RE: FORMER BARTONS INFANT SCHOOL, BERSTED
Council Ref: BE/40/22/PL

Technical Note in response to LLFA comments

Drawing Number	11642/1601	Rev.	P5
----------------	------------	------	----

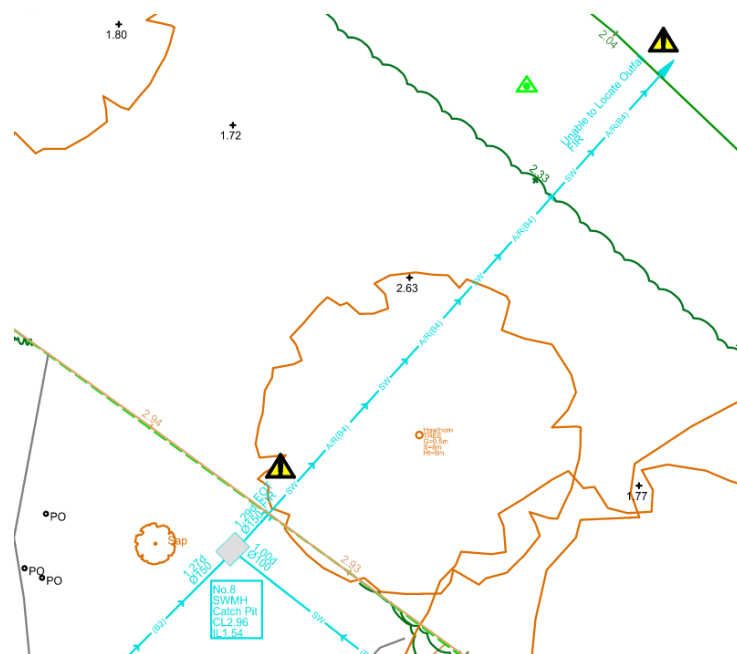
- 4) We require the fences to be at least 3m from top of bank, between the development and ancient watercourse, to ensure that the proposals are in accordance with our land drainage byelaws. This easement should be delineated and confirmed on the drainage layout plan.
- From the information provided it appears that a 2m easement (approximately) has been provided for access and maintenance of the watercourse at present. It is recognised that no buildings are located within 5m (as is also required).

We have clarified the location of the top of bank of the watercourse and shown a 3.5m easement to a relocated fenceline location on amended drawing 11642/1601 rev P5 appended.

Extract of utilities survey showing existing school outfall

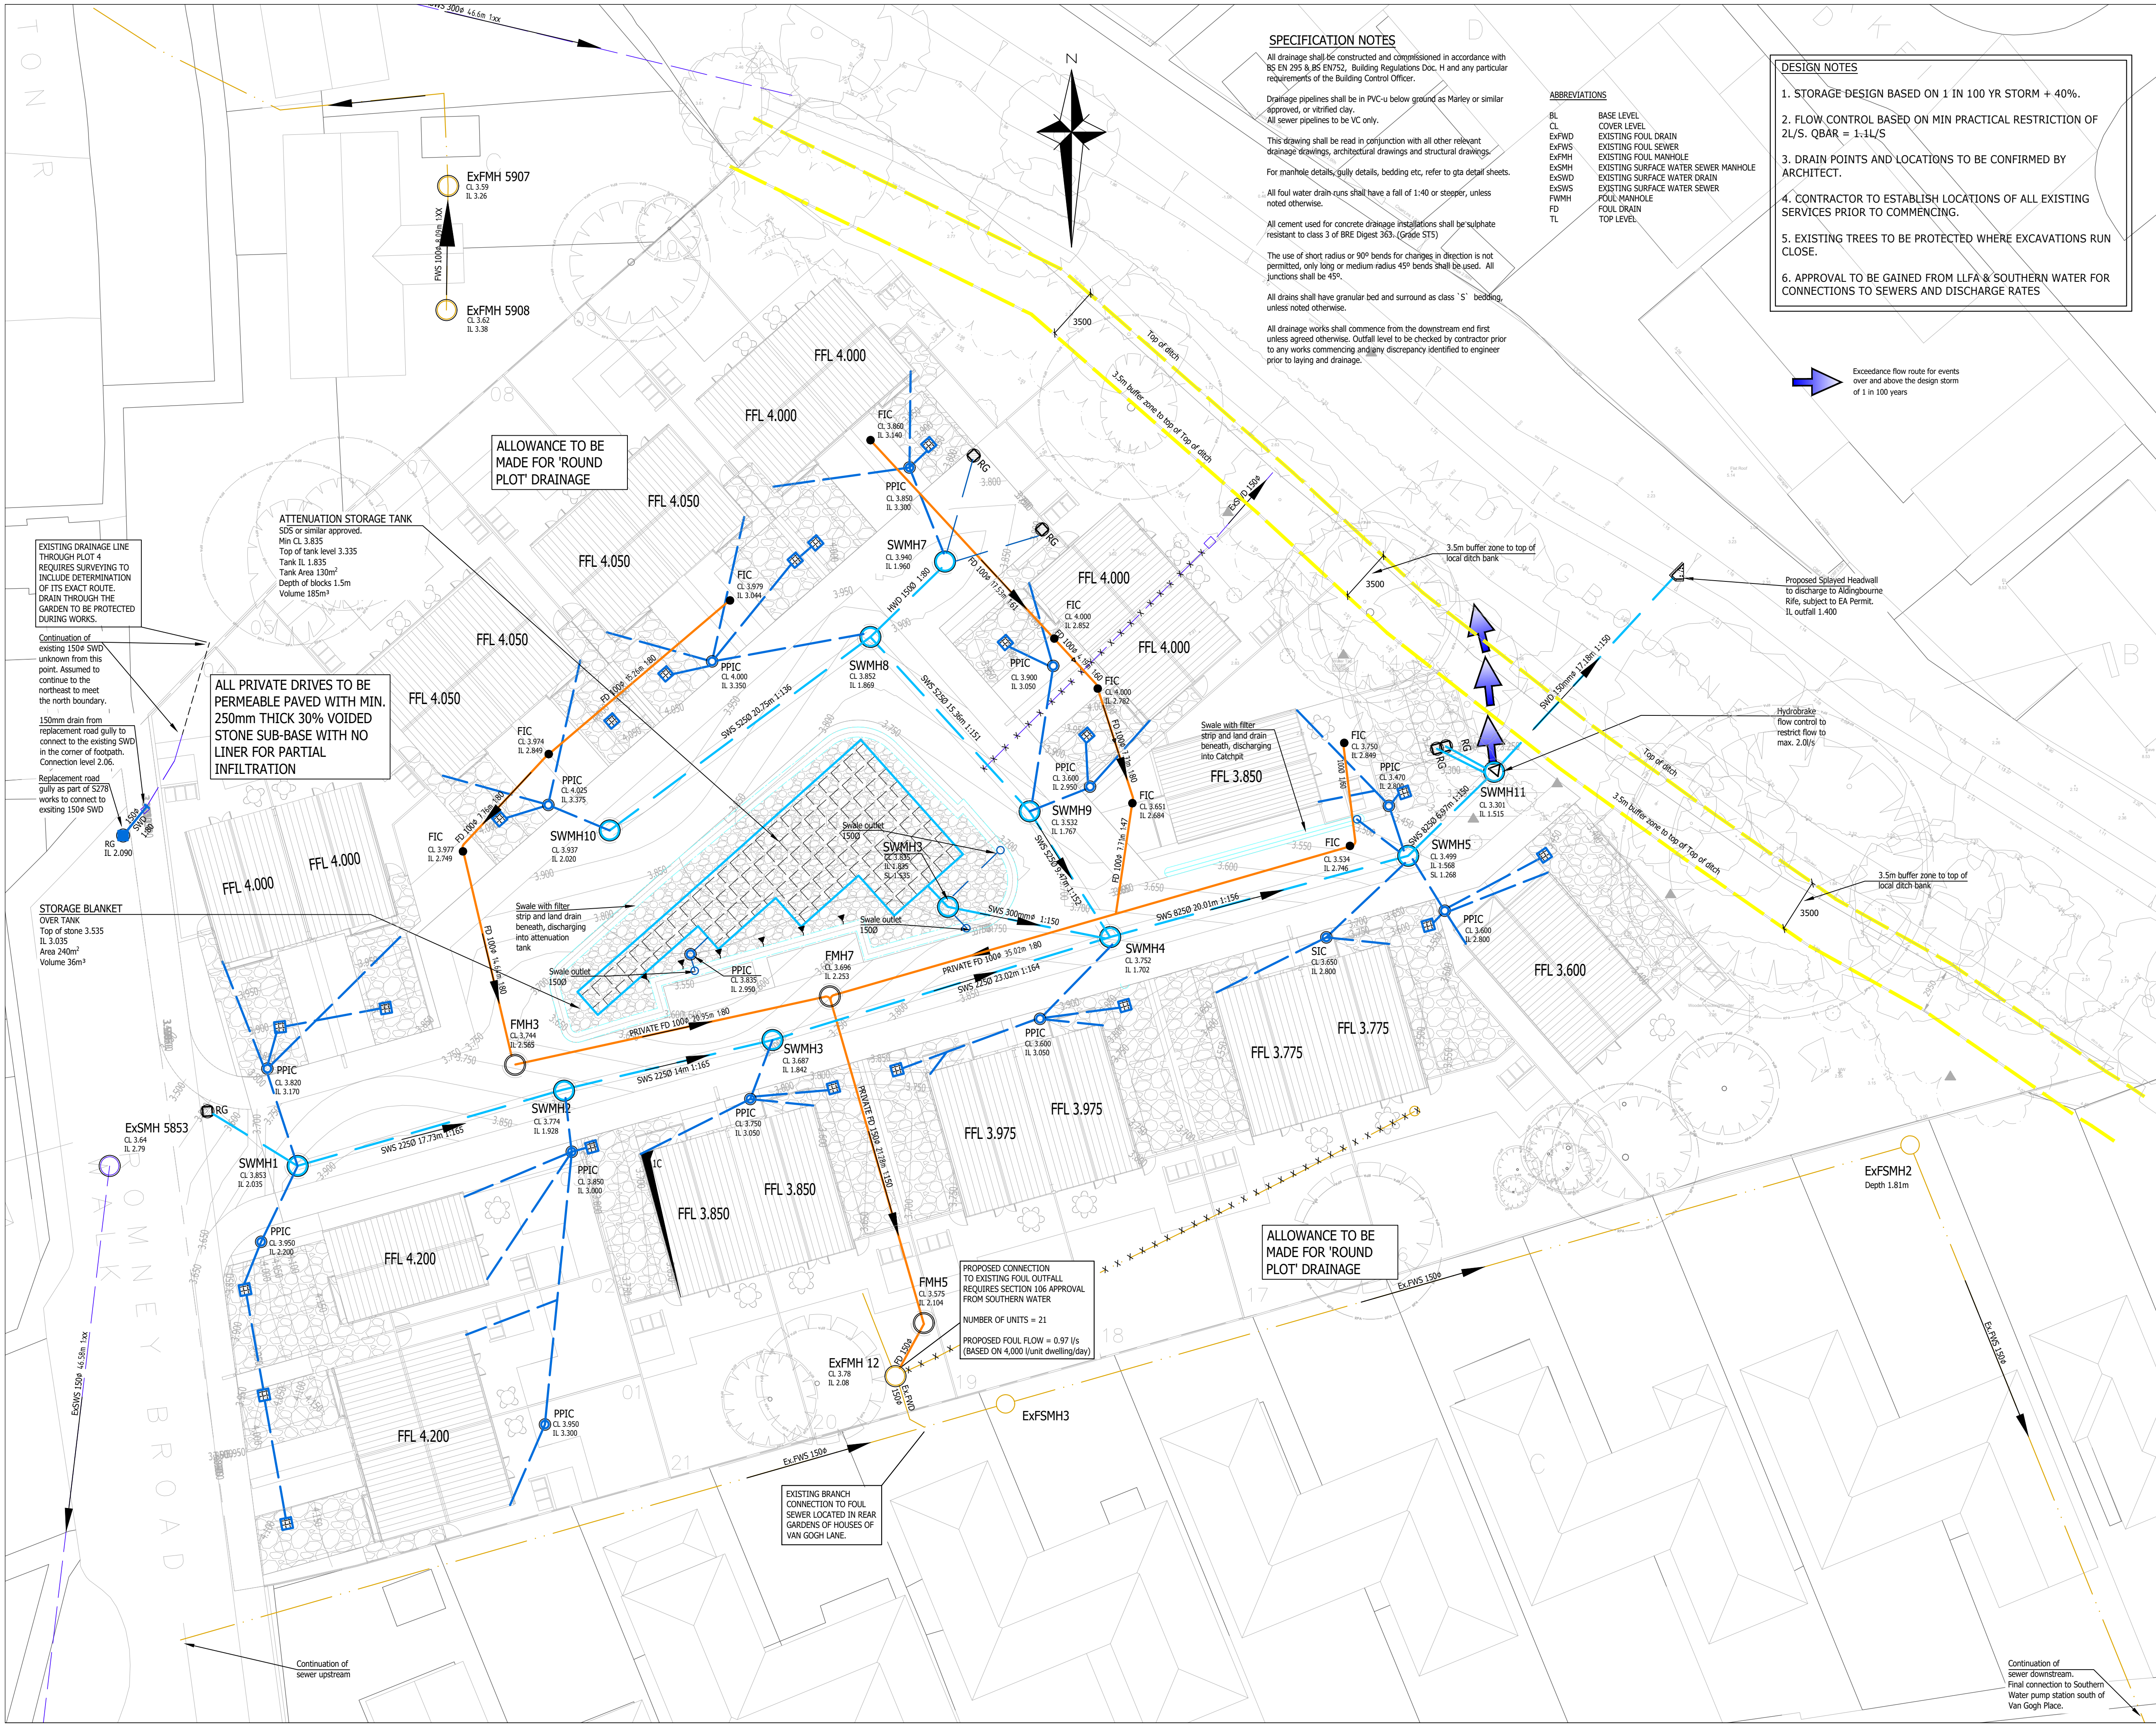
- 5) We are unsure how the ditch / small watercourse adjacent to the site connects to the nearby main river and we have concerns regarding how onward connection from the development site to this watercourse, or the main river will be achieved.

- The drainage layout shows the proposed onward connection to the main river crossing the smaller ditch channel. There is likely to be works required to facilitate the connection as shown, or to ensure the ditch / small channel is fit for purpose and has onward connectivity to the main river if a connection to this feature is proposed at the detailed design stage.

- We require additional details of the proposed connection, including whether an existing connection between the main river and smaller channel is present.

- We require details of how any pipework can be accommodated / will pass through the area where the existing ditch / channel is. This pipework should remain above the water level within the main river.

We have searched the area and we cannot find connectivity between the small watercourse and main river due to dense undergrowth.

The proposed connection is mimicking the existing school outfall location which is shown on the survey plan appended, extract below:

The only reason this existing outfall was not used was that it is not in a convenient location for future maintenance, as the manhole falls in the garden of plot 13.

The level of the existing outfall is likely to be somewhere in the region of 1.4m AOD (as upstream chamber is 1.54m) which is what we are proposing, so the new outfall will have no more impact than the existing, especially taking into account this used to have no flow restriction from the school site.

The main rife ditch bed level has been surveyed at approximately 1.020m AOD in the vicinity of the connection with no water level in the rife present. So the connection is 380mm above bed level which we feel is more than sufficient.
